ADDENDUM NO.1

Ayer West Main Street Infrastructure Project, No. 21DPW11  
Ayer DPW

This addendum amends and/or supplements the bid documents as indicated below. Only these items alter the Bid Documents; any verbal discussions or responses are hereby declared null and void.

2 PIER PLAN  
1 1/2" = 1'-0"

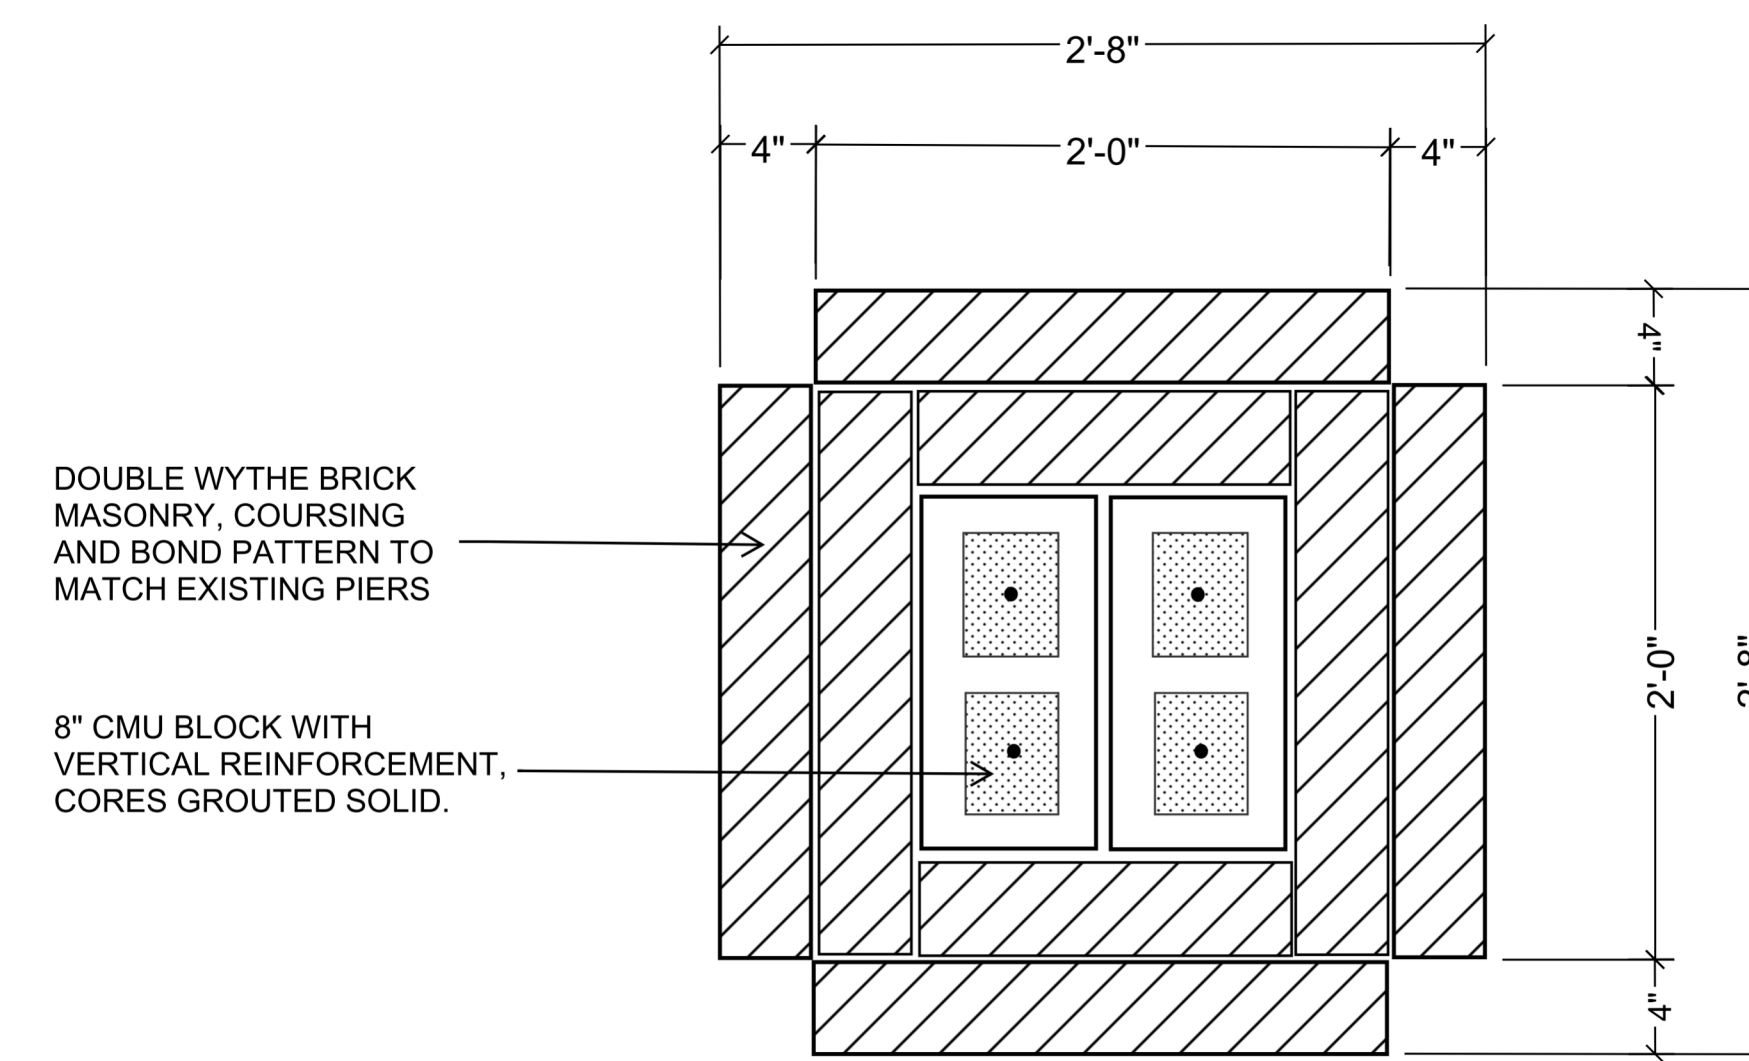
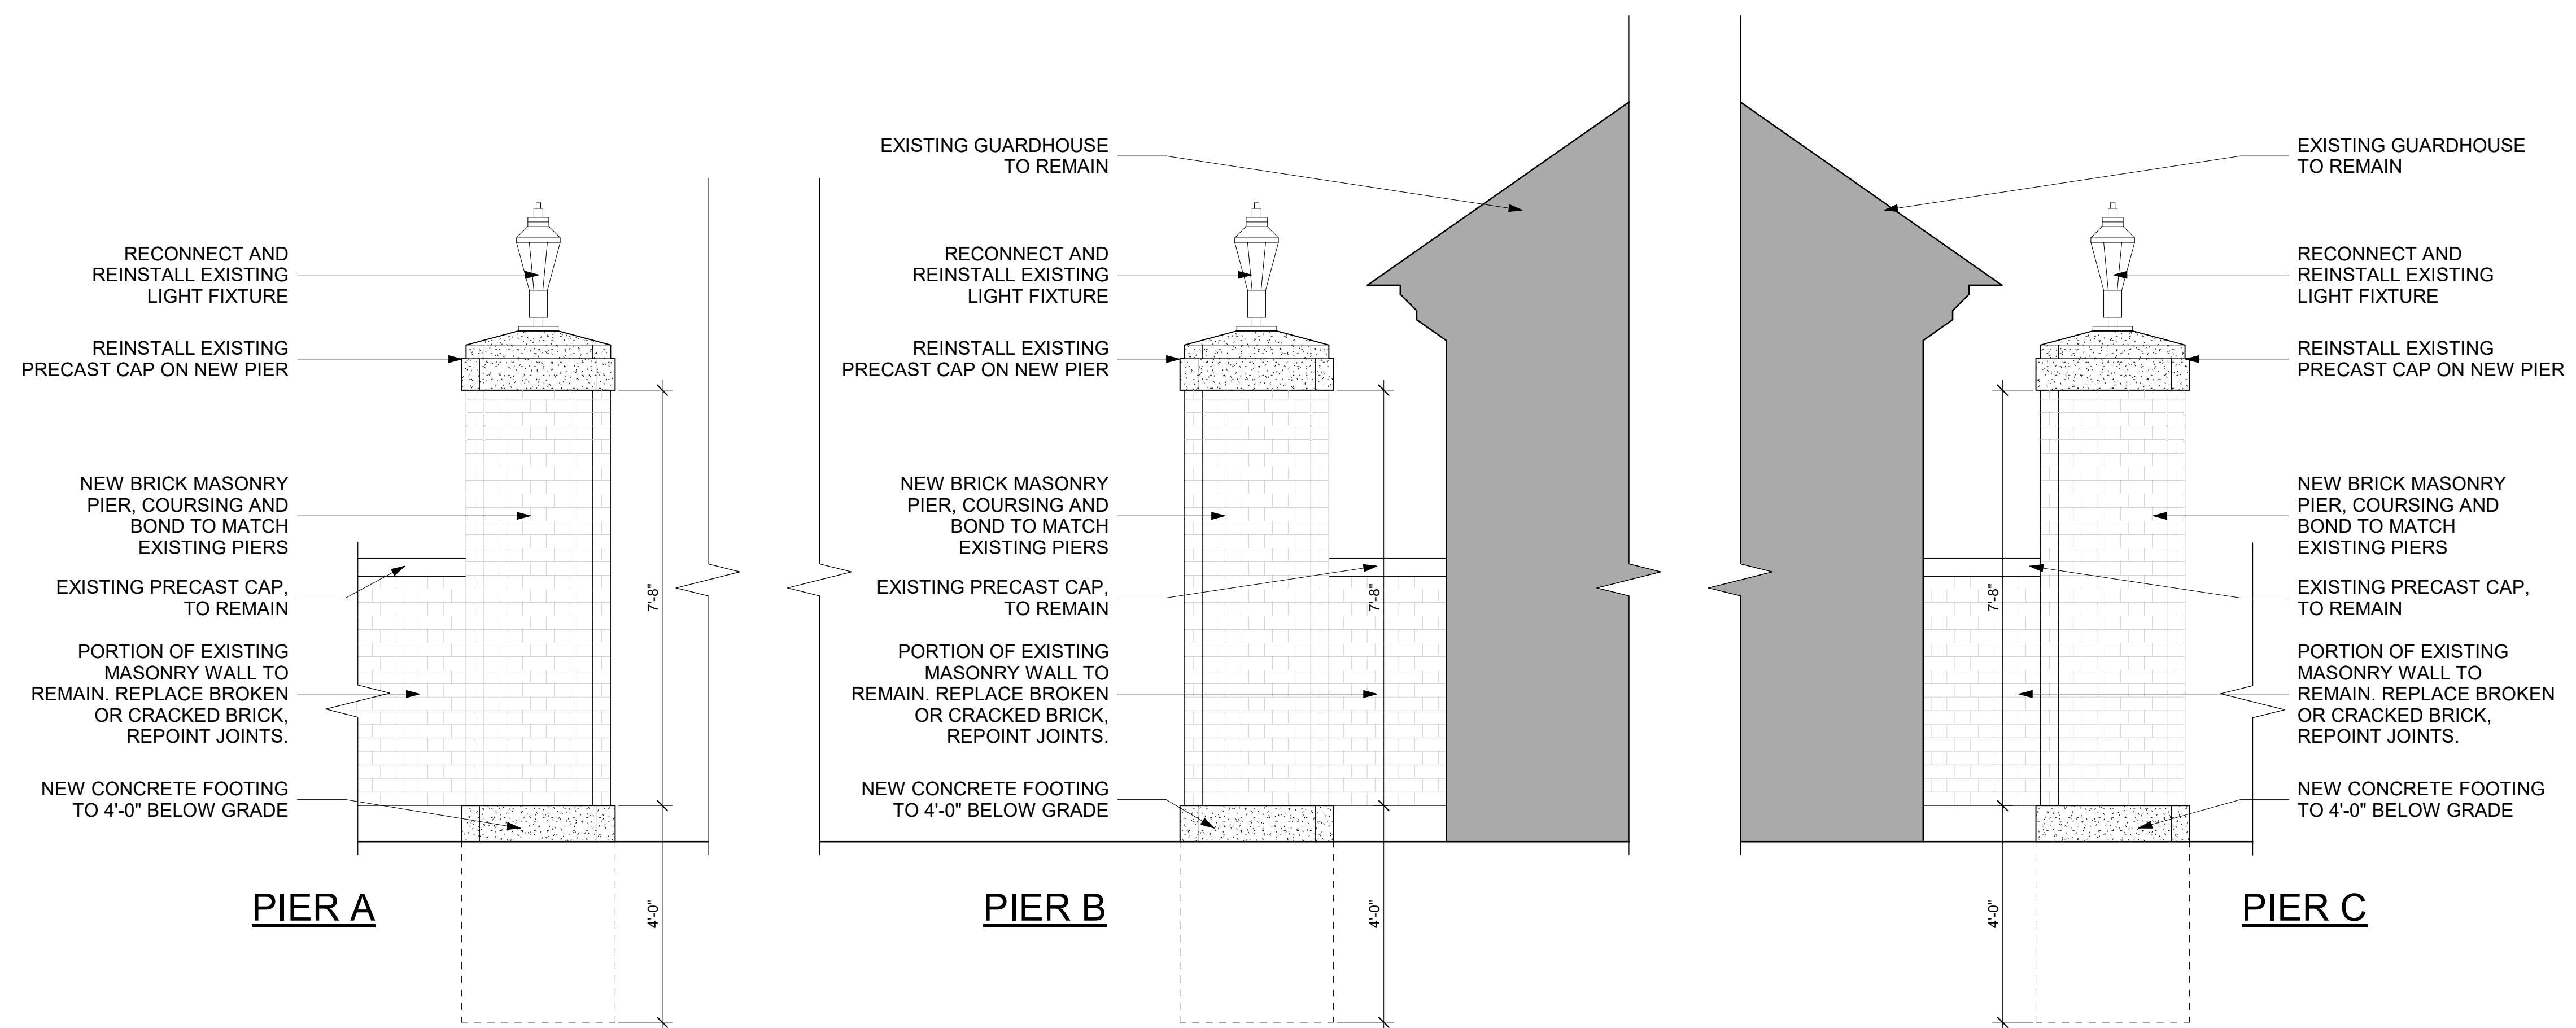
6. **On the pilers or piers, could a detail be given on the footers size and rebar to be used? Also will there be a mesh on the blocks and ties to attach the bricks? If so can a detail be given?**

1. Use Hohman and Barnard Mesh Wall Tie (MWT or equal) at corners, every 4<sup>th</sup> course.
2. Use Hohman and 345 BT Adjustable tie (or equal) every 4th course, 2 ties per elevation.

3. The bottom of footing must be 4'-0" below grade as indicated on drawing A-102. The footing should be 3'-4" x 3'-4" x 4'-0" deep, #4 vertical rebar w/ #4 stirrups. The above grade portion of the footing (8") must match the profile of the existing footings, see photo attached.
